MEMORANDUM

Date: January 06, 2015
To: David Bonk, Kumar Neppalli, PE
Town of Chapel Hill, North Carolina
From: Bill Schultheiss, PE
Re: South Columbia Street and Otey's Road Safety Review and Concept Development

Toole Design Group (TDG) was retained by the Town of Chapel Hill to review a concept design developed by Kimley-Horn and Associates, Inc. (KHI) at the northern intersection of South Columbia Street at Fordham Boulevard (attached as exhibit 2), to develop concept design alternatives for South Columbia Street from Purefoy Road to Culver Road, and to develop a crossing improvement concept for Otey's Road at Fordham Boulevard.

Existing pedestrian and bicycle access and safety challenges

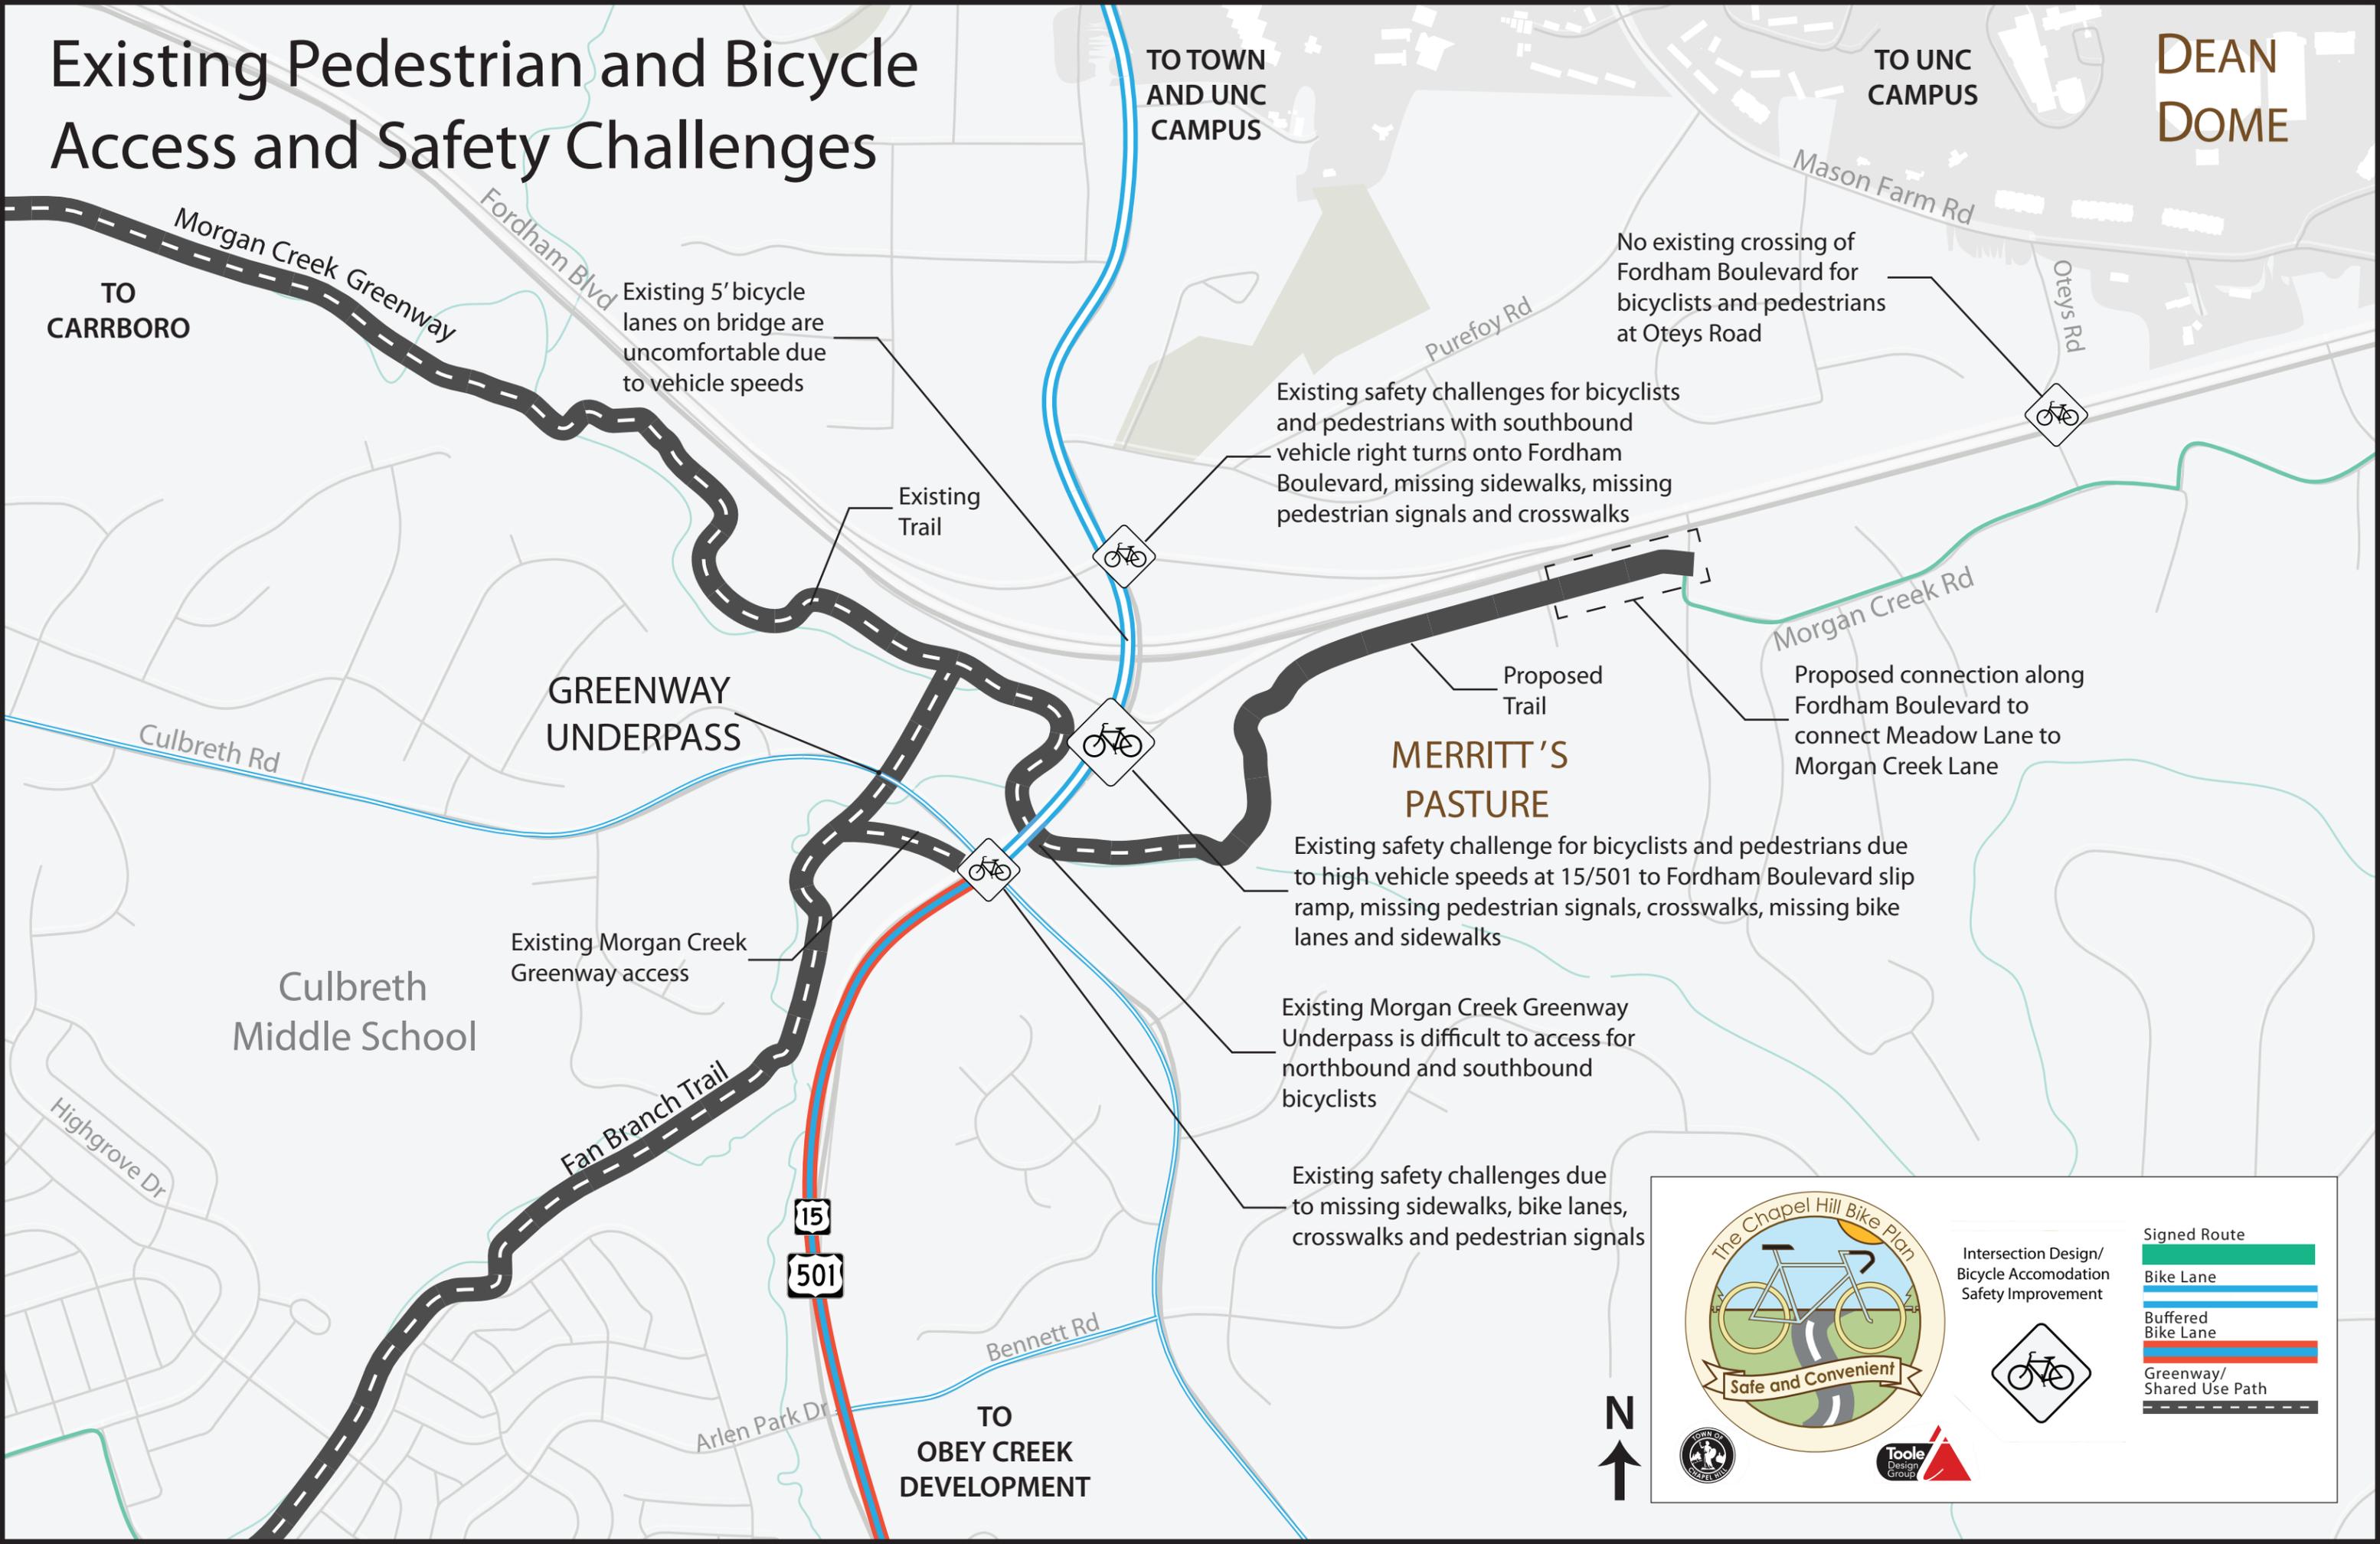
- Absence of street lighting along South Columbia Street
- Missing sidewalks along the east side of the street south of Fordham Boulevard
- Free flow right turn lane that allows high speed turns for northbound right turn onto Fordham Boulevard
- The size of the intersections increase exposure of bicyclists and pedestrians to turning traffic and allow traffic to turn at higher speeds
- Incomplete trail connections through Merritt's Pasture to allow alternate route to UNC Campus via Morgan Creek Road
- Missing crossings to allow pedestrians and bicyclists to cross South Columbia Street
- Unclear delineation of bicyclists path through merging areas reduces clarity of right-of-way at start of right turn lanes

The deficiencies identified in Exhibit 1 are based on direct observation by TDG staff, a review of the proposed KHI alternative, and input provided from the public through the Town and University Bike Plans.
